From: Miles, Larisa
Sent: 11 June 2013 03:11
To: Product Change Notices
Cc: Boyce, Mary E; Bella, Salvatore J
Subject: FW: Kemet PCN
Attachments: Copy of Ends in NJ (2) - 6-10-13.XLSX

As a result of feedback from our customers and an attempt to unify product part numbers globally AVX is intending to revise the standard TAJ series part number (PN) to include the *NJ ending as the last suffix letters.

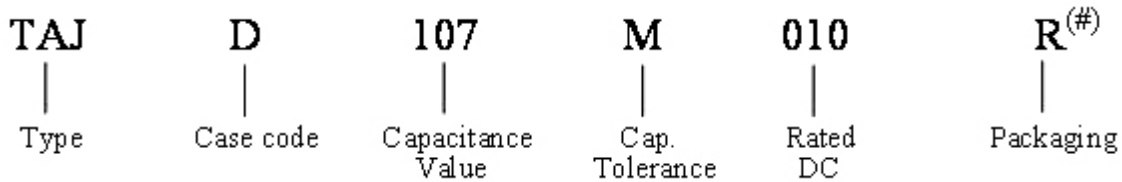
This is the new nomenclature that AVX will use
For example this part **TAJD106M035R** , will be sent to you as **TAJD106M035RNJ**

The new PN structure maintains the first suffix letter (#) and adds the two additional characters NJ to the suffix. The older PN structure and the new PN structure refer to the same product so there is no change in form, fit or function.

The new NJ suffix part number will be mandatory for all new specification builds and replaces the old part number. The older part number structure will be maintained for already running projects only.
